Date: SEP 29 2010
Refer To: EP2010-0435

Subject: Submittal of the Response to the Requirement to Discontinue Use of Brüel and Kaejer Multigas Analyzer for Field Screening of Volatile Organic Compounds at Material Disposal Areas G, H, and L, at Technical Area 54

This letter is in response to the above-referenced letter from the New Mexico Environment Department (NMED) regarding screening volatile organic compounds (VOCs) at Material Disposal Areas (MDAs) G, H, and L.

Figure 1. Correlation for TCA (all data)

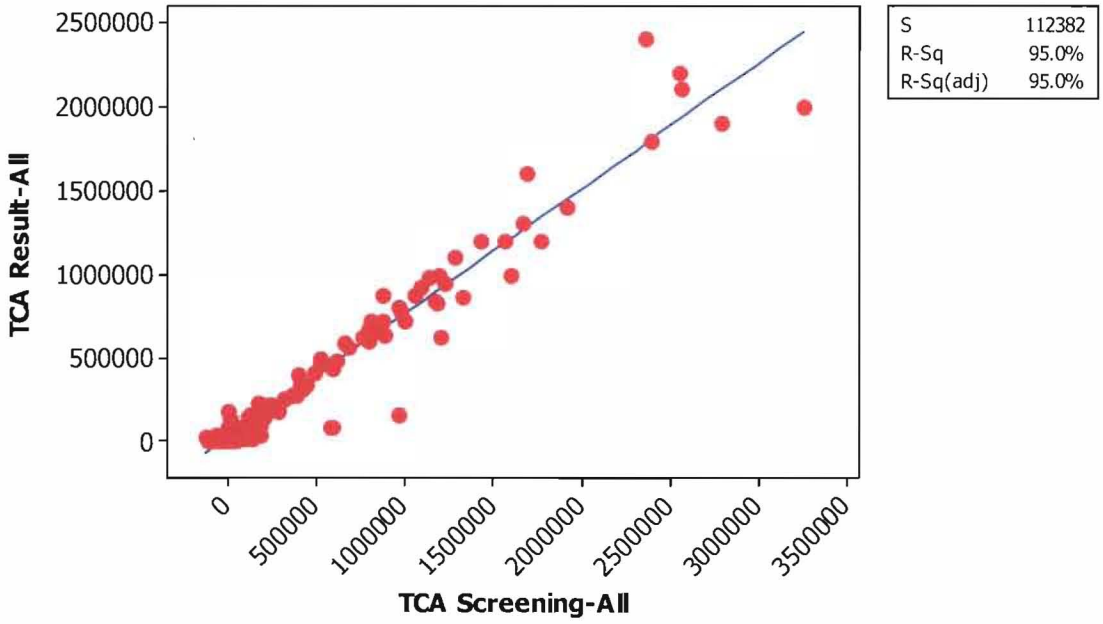
Figure 1 shows the correlation for TCA field-screening results and analytical data from the three sampling events combined. The R-Square value of 95% indicates a statistically significant correlation between the TCA field-screening results and the analytical data.

Figure 2. Correlation for TCA Results < Henry's Law Screen

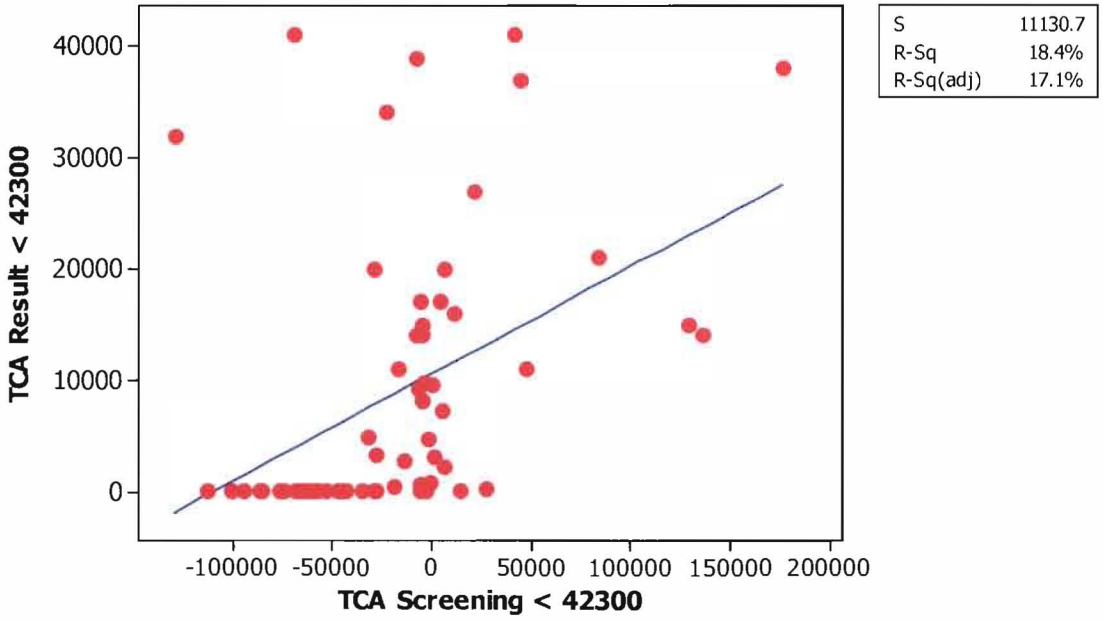
As previously noted by NMED, there are often negative values for the screening results. These values are usually associated with low concentration areas, such as what is observed at MDA H. To evaluate the impact of lower TCA concentrations on the correlation, the pore gas-groundwater equivalency concentration (based on Henry's Law and defined in the vapor periodic monitoring reports) was used as a threshold concentration. Figure 2 shows the TCA correlation for concentrations less than 42,300 $\mu g/m^3$ (poor correlation, R-Square = 18.4%), and Figure 3 shows the TCA correlation for concentrations greater than 42,300 $\mu g/m^3$ (good correlation, R-Square = 93.3%). This analysis demonstrates that for low concentration areas, such as at MDA H, the usefulness of the B&K instrument as a screening instrument is limited. However, at areas with higher concentrations of TCA, such as MDAs L and G, the B&K instrument provides useful information without collecting an analytical sample at every sampling port. The examples of poor correlation cited in NMED's letter had TCA analytical concentrations less than 42,300 $\mu g/m^3$.

Figure 4. Correlation for TCE (All Data)

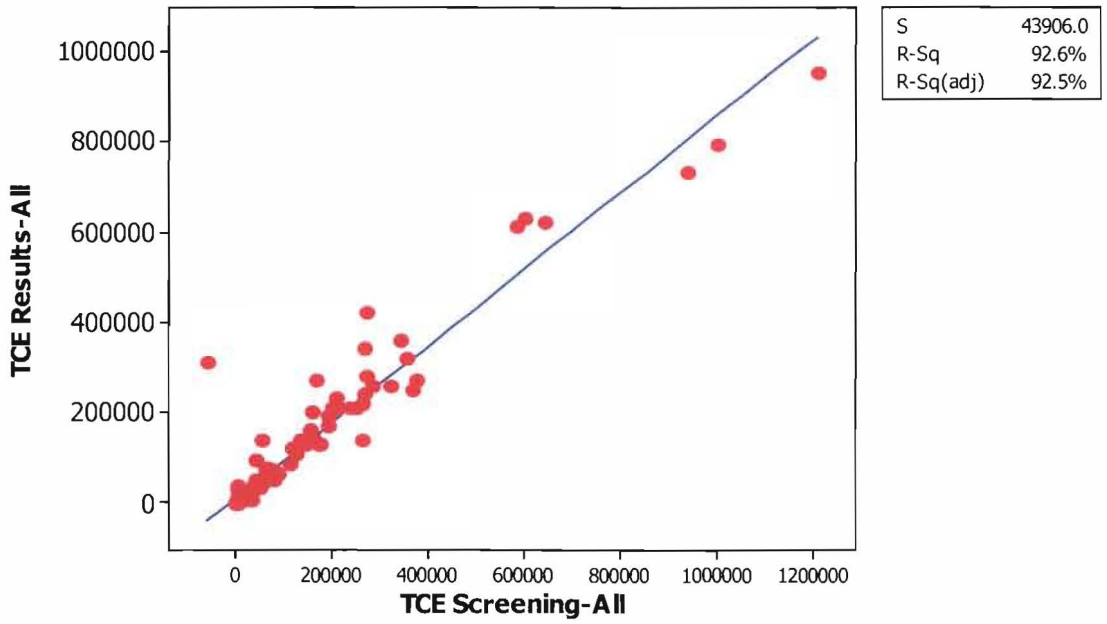
Figure 4 shows the correlation for all of the TCE field-screening results and analytical data from the three sampling events combined. The R-Square value of 92.6% indicates a statistically significant correlation between the TCE field-screening results and the analytical data.

Figure 5. Correlation for TCE Results < Henry's Law Screen

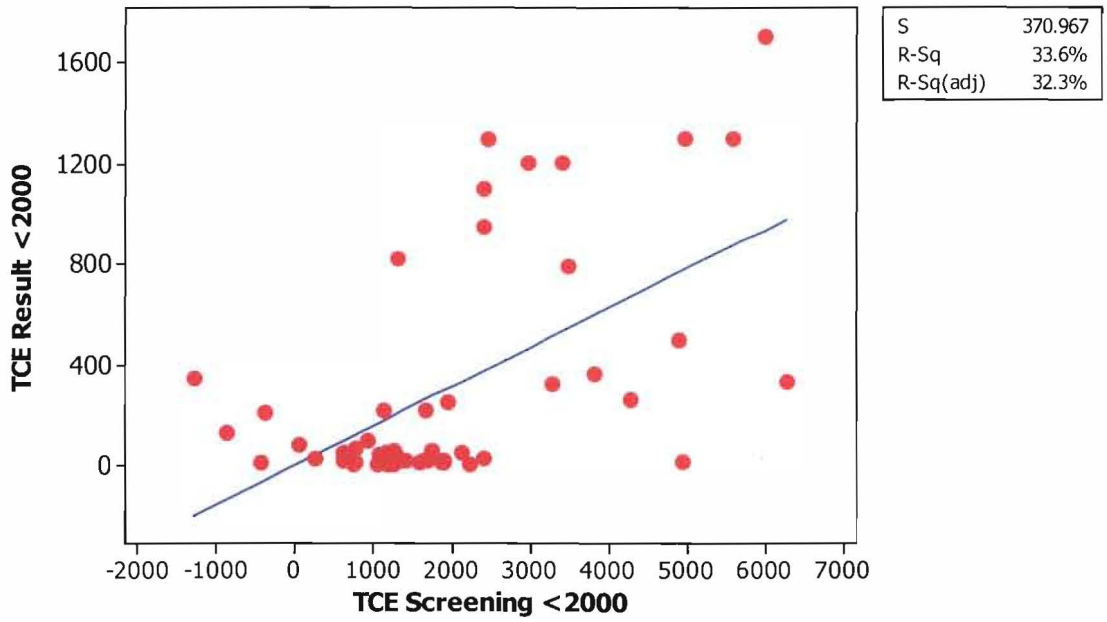
As with the TCA data, to evaluate the impact of lower TCE concentrations on the correlation, the pore gas-groundwater equivalency concentration (based on Henry's Law) was used as a threshold concentration. Figure 5 shows the TCE correlation for concentrations less than 2000 $\mu g/m^3$ (poor correlation, R-Square = 33.6%), and Figure 6 shows the TCE correlation for concentrations greater than 2000 $\mu g/m^3$ (good correlation, R-Square = 91.5%). Again, this analysis demonstrates that for areas with low concentrations of TCE, such as at MDA H, the usefulness of the B&K instrument as a screening instrument is limited. However, at areas with higher concentrations of TCE, such as MDAs L and G, the B&K instrument provides useful information without collecting an analytical sample at every sampling port. The examples of poor correlation cited in NMED's letter had TCE analytical concentrations less than 2000 $\mu g/m^3$.
